Field Installation Instruction

Motor Speed Control Model 3984 Isolated Interface Module

DOC NBR: TEC-303

Rewiring the Motor Control TAC signal

Figure 1. Before Rewire (Rev 2)

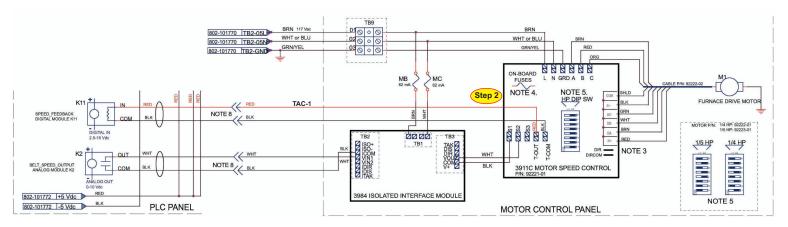
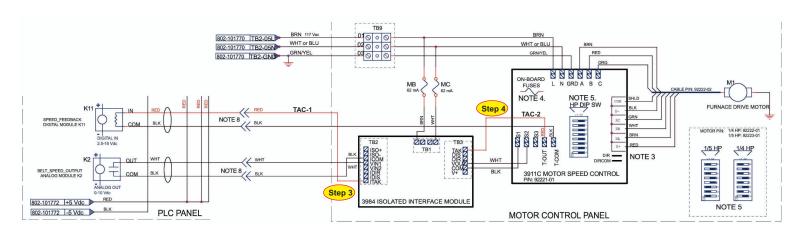
- 1. Make sure furnace power is off.
- 2. Disconnect red TAC-1 wire at T-OUT terminal on 3911C Motor Speed Control board (figure 1).
- 3. Connect red TAC-1 wire to TB2-ITAK terminal on 3984 Isolated Interface module (figure 2).
- 4. Connect a new red TAC-2 wire from TB3-TAK on 3984 Isolated Interface module to T-OUT on 3911C Motor Speed Control board (figure 2).
- 5. Follow instructions on TEC-303 to adjust pots, start furnace. Calibrate belt speed.

Figure 2. After Rewire (Rev 3)
